MAS003405 RU 23-13

Rapid Update 578 Grecale – Door Button Loose

DATE: APRIL 18 2023

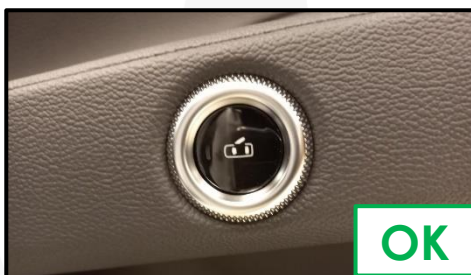
In very few cases, due to a deformation of the hooking teeth, the hooking trim can slip when the button is pressed.

1. Always check ModisCS+ to see if the vehicle is involved in this action and if it has not been previously performed.
2. Check the functionality of the interior door open buttons for all 4 doors by performing 5 opening/closing cycles for each door.

- **OK** -> buttons remain secure to the ring plates and the door opening command works well for each cycle. Procedure complete. No other actions required.

- **NOT OK** -> Push button detached partially from the ring plate and gets stuck, or it detaches totally and falls into the door panel ► Replace the faulty component following the appropriate procedure, indicated below:

- a. 08.52.071 - RH SWITCH FRONT DOOR LOCK - Removal/refitting or replacement
- b. 08.52.072 - LH SWITCH FRONT DOOR LOCK - Removal/refitting or replacement
- c. 08.52.073 - RH SWITCH REAR DOOR LOCK - Removal/refitting or replacement
- d. 08.52.074 - LH SWITCH REAR DOOR LOCK - Removal/refitting or replacement
